# Access Compliance Report

## Public Rights-of-Way

### (Curb Ramps)

Intersection ID: N/A	Main Street: VISTA_VERDE_CT	Cross Street: N/A	Location: NE
ADA ID: 144E03D85959	Ramp Type: Perp	Initial Pass/Fail: Fail	Overall Compliance: No
Severity Score: 12.5			
Codes/Mitigation Info/Possible Solution		Field Measurements/Component Compliance

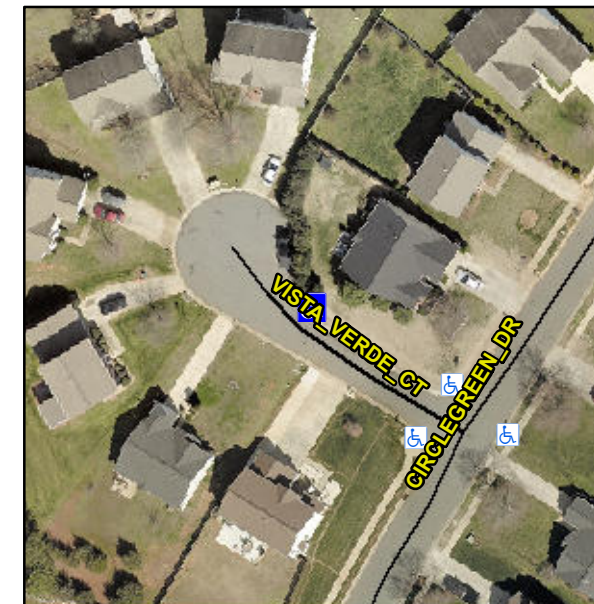
**R304.2.2**

Compliance	Description	Data	Compliance	Description	Data
N/A	Ramp Length (in)	48.0	No	Ramp Slope (%)	10.1
Yes	Ramp Width (in)	48.0	Yes	Ramp XSlope (%)	0.4
N/A	Flare Type LT	N/A	N/A	Flare Type RT	N/A
N/A	Flare Slope LT (%)	N/A	N/A	Flare Slope RT (%)	N/A
N/A	Flare Traversable LT?	N/A	N/A	Flare Traversable RT?	N/A
N/A	Landing Length (in)	N/A	N/A	DWS Provided?	N/A
N/A	Landing Width (in)	N/A	N/A	DWS Contrast?	N/A
N/A	Landing Slope (%)	N/A	N/A	DWS Length (in)	N/A
N/A	Landing X Slope (%)	N/A	N/A	DWS Full Width?	N/A
N/A	Landing Curb? (Y/N)	N/A	N/A	DWS Offset (in)	N/A
N/A	Shared Landing?	N/A			
N/A	Gutter Ponding?	N/A	N/A	Gutter Slope (%)	N/A
N/A	Gutter Lip Ht (in)	N/A	N/A	Gutter X Slope (%)	N/A
N/A	Painted X Walk1?	No	N/A	Painted X Walk2?	N/A
	X Walk 1 Direction	To SW		X Walk 2 Direction	N/A
N/A	X Walk 1 Width (in)	N/A	N/A	X Walk 2 Width (in)	N/A
	X Walk 1 Slope (%)	4.9		X Walk 2 Slope (%)	N/A
	X Walk 1 X Slope (%)	2.5		X Walk 2 X Slope (%)	N/A

**Remove & Replace Entire Ramp.**
